# GRIFFEY ENGINEERING, INC.

RE: Hillside Groves SR 19 Access Connection

# HILLSIDE GROVES SR 19 ACCESS CONNECTION STANDARD 55 MPH CONNECTION w/ TURN LANES

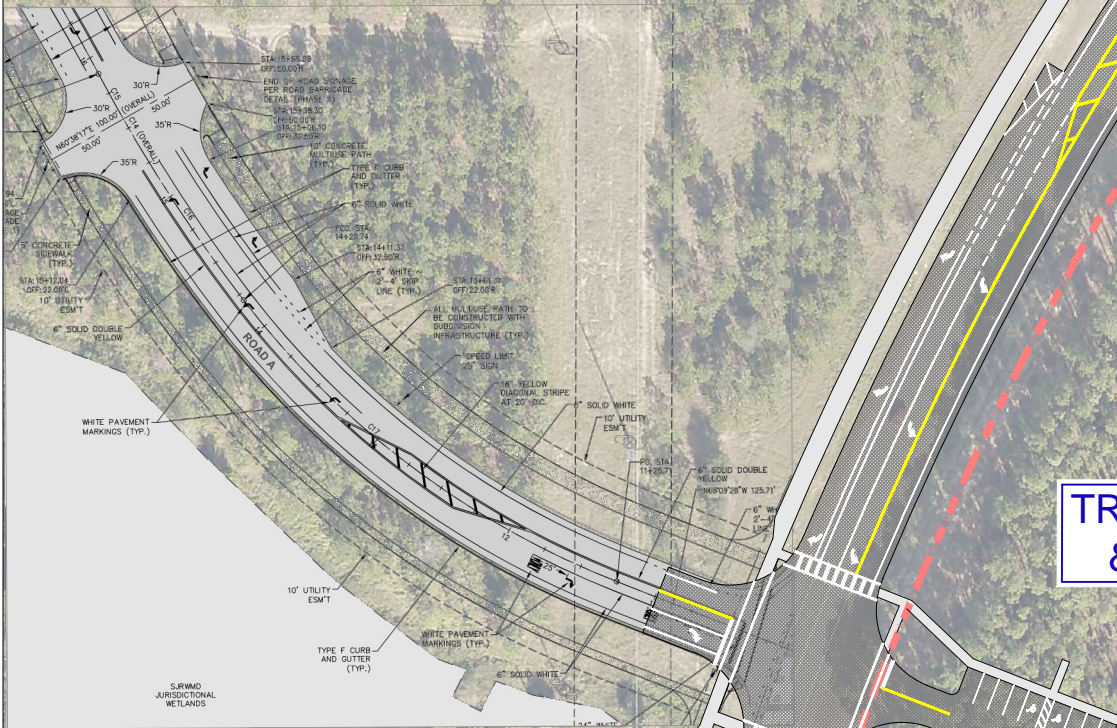
Regarding Hillside Groves, they told us that the proposed three lane connection (one inbound and two outbound lanes) complies with the FDOT Design Manual. A four lane road (two inbound and two outbound lanes) with a median does not comply with their standards, and that the projected traffic volumes do not necessitate four lanes. The width restriction is primarily due to safety concerns, particularly for cyclists and pedestrians. This is a reasonable concern since the project is being designed to promote bicycle and pedestrian usage. The FDOT staff said that they were not inclined to waive the width standards because they saw this connection application as the first phase of the development. When the commercial portion of the project comes forward, the access connection will be reevaluated and repermited by FDOT. If the existing and proposed traffic volumes at that time warrant the additional inbound lane, they would approve it.

During the meeting they stated that their preferred configuration for this connection would be a roundabout. I have since reviewed the location and have determined that a roundabout could be constructed there. I have attached two exhibits for this connection. One shows the standard connection with turn lanes (as depicted in the construction plans), the other is a roundabout intersection. My opinion is that the roundabout is the best option for this access connection. The advantages of the roundabout include: It will slow down the traffic coming into town and FDOT said that we could reduce the speed limit on SR 19 from the roundabout to Florida Ave.; It will reduce the number and severity of potential crashes at the new intersection; It will improve safety for pedestrians and cyclists; It will provide a safe connection between the Pine Park trailhead and the Central Lake Trail; It will function as a gateway feature; And it will eliminate the need for a future traffic signal thus eliminating a perpetual cost to the town for operation and maintenance.
